- 13. Peaceful Acres Redwine Addition; KPB File 2023-122
Segesser Surveys / Redwine
Location: Cardwell Road
Kalifornsky Area / Kalifornsky APC**

**ITEM #13 - PRELIMINARY PLAT
PEACEFUL ACRES REDWINE ADDITION**

KPB File No.	2023-122
Plat Committee Meeting:	November 13, 2023
Applicant / Owner:	George Redwine of Soldotna, AK
Surveyor:	John Segesser / Segesser Surveys
General Location:	Kalifornsky Area

Peaceful Acres
Redwine Addition

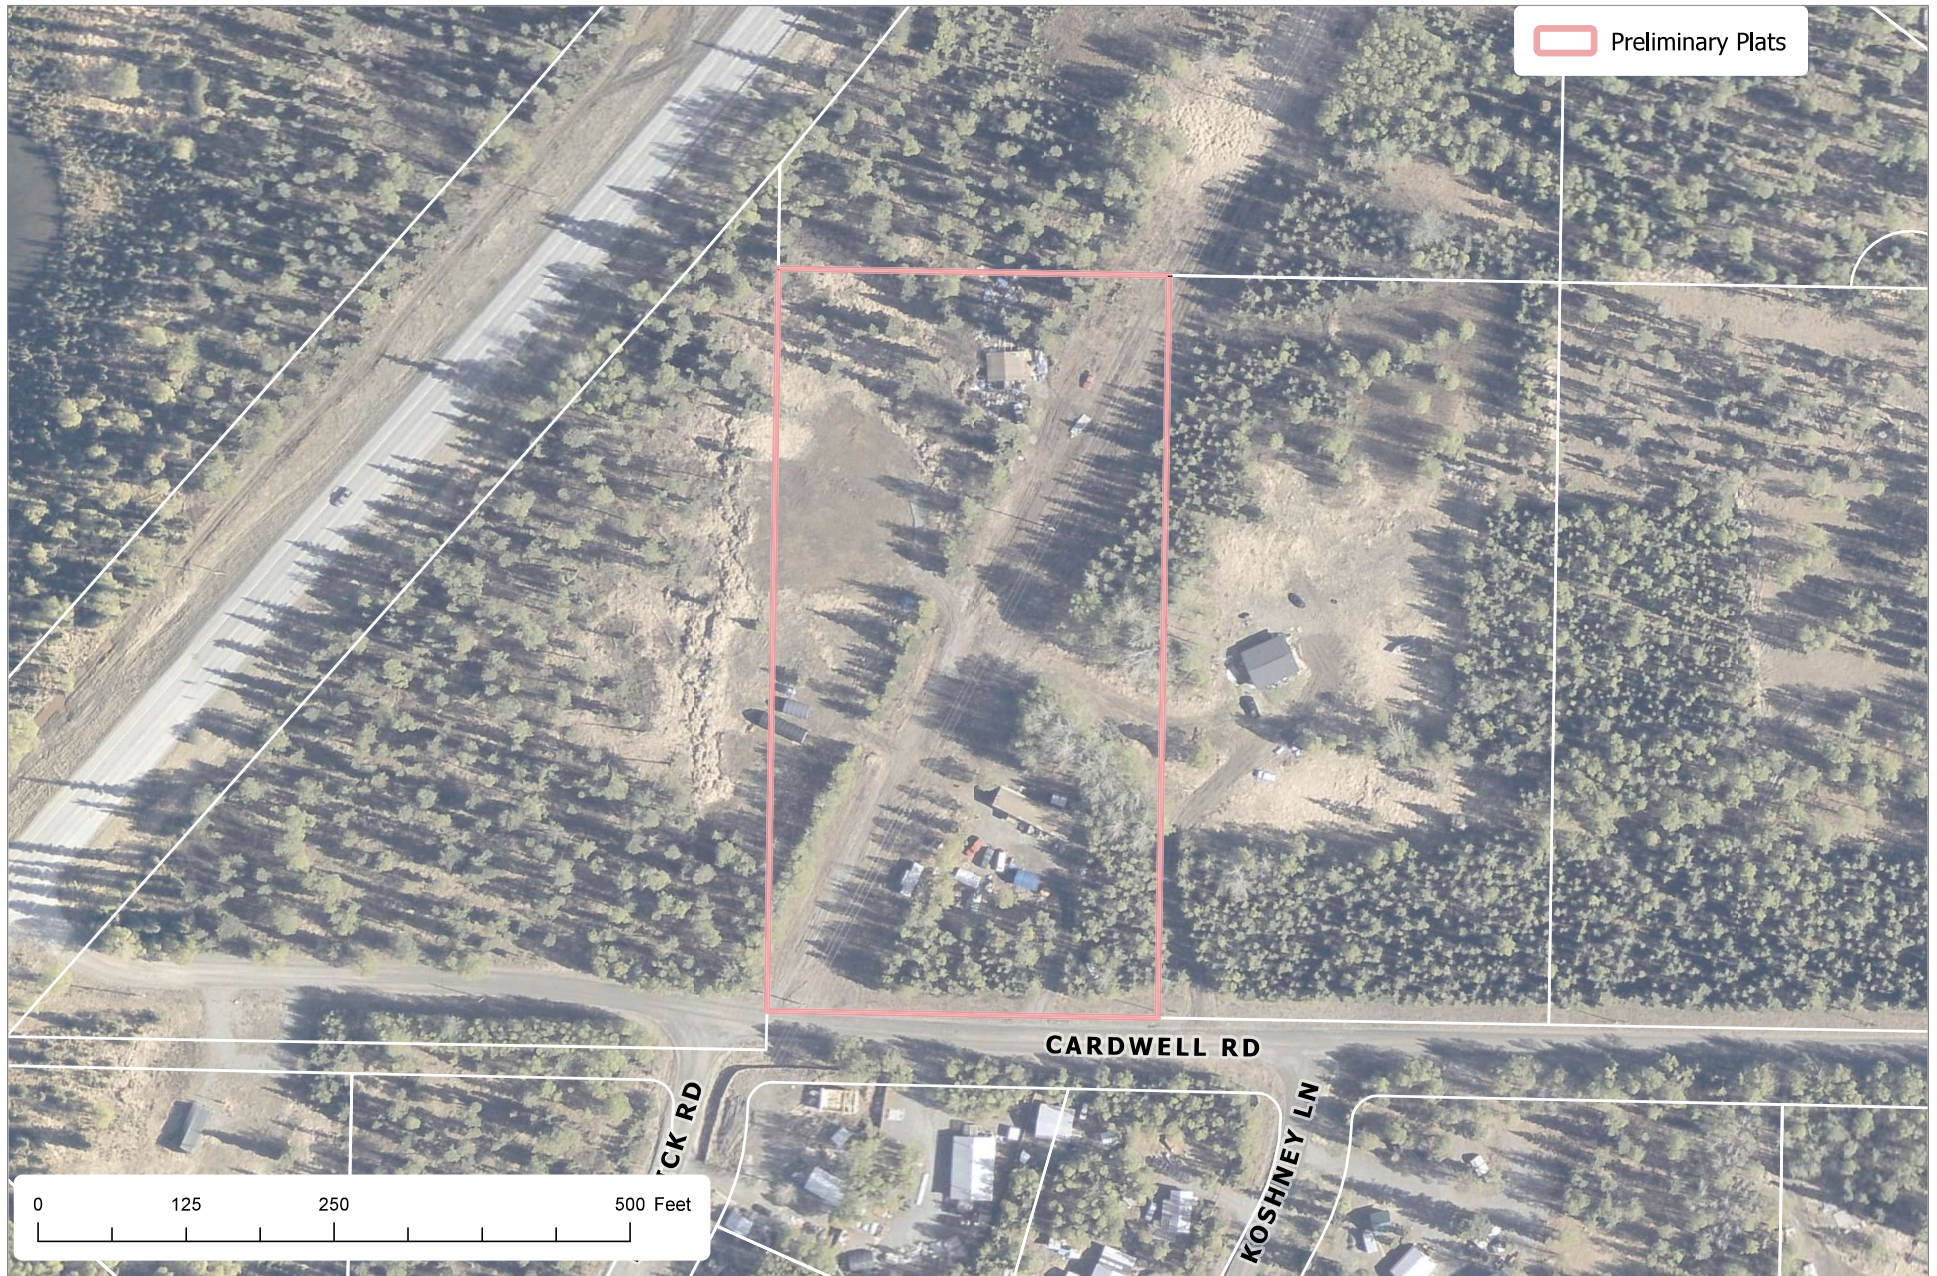
The cul-de-sac does not have a name shown on the dedication. ***Staff recommends: the surveyor get with Addressing to obtain an approved name.***

dedication, with one possibly encroaching across the west line. **Staff recommends:** *the surveyor confirm the location of the structures on the west and give a report to staff on location and any remediation to be taken if needed.*

Utility Easements There is a 100-foot Transmission Line Easement and a 10' by 100' Utility easement being carried forward from KN2003-16. **Staff recommends:** *the surveyor locate the poles for the center of the 100-foot easement and shown correctly on plat drawing.*

On plat note 5, fourth line down, line is misspelled as lie, please correct.
Add date of November 13, 2023 to Plat Approval.

Add KPB file No 2023-122
Add total area to Title Block

- D. A vicinity map, drawn to scale showing location of proposed subdivision, north arrow if different from plat orientation, township and range, section lines, roads, political boundaries, and prominent natural and manmade features, such as shorelines or streams;
Staff recommendation:
Add Cardwell Rd and Johns Rd to the vicinity map
Change Irish Hills Rd to Irish Hills Ave
Remove the triangle in section 4.

- G. The status of adjacent lands within 100 feet of the proposed subdivision boundary or the land status across from any dedicated rights-of-way that adjoin the proposed subdivision boundary, including names of subdivisions, lot lines, block numbers, lot numbers, rights-of-way; or an indication that the adjacent land is not subdivided;
Staff recommendation: Parcels to the south need updated labels.

- N. Apparent encroachments, with a statement indicating how the encroachments will be resolved prior to final plat approval;
Staff recommendation: Appears to be an encroachment on west crossing onto adjacent land, please confirm structure locations.

Record datum is mentioned, but none is given, surveyor should give record information where appropriate.

Staff recommendation: provide boundary and lot closure computations with the paper final plat. KPB will verify closure complies with 20.60.120. Boundary does not close.

Add Certificate of Acceptance for road

Staff recommendation: comply with 20.60.200 Show monuments set.

Tie into BLM / GLO monuments
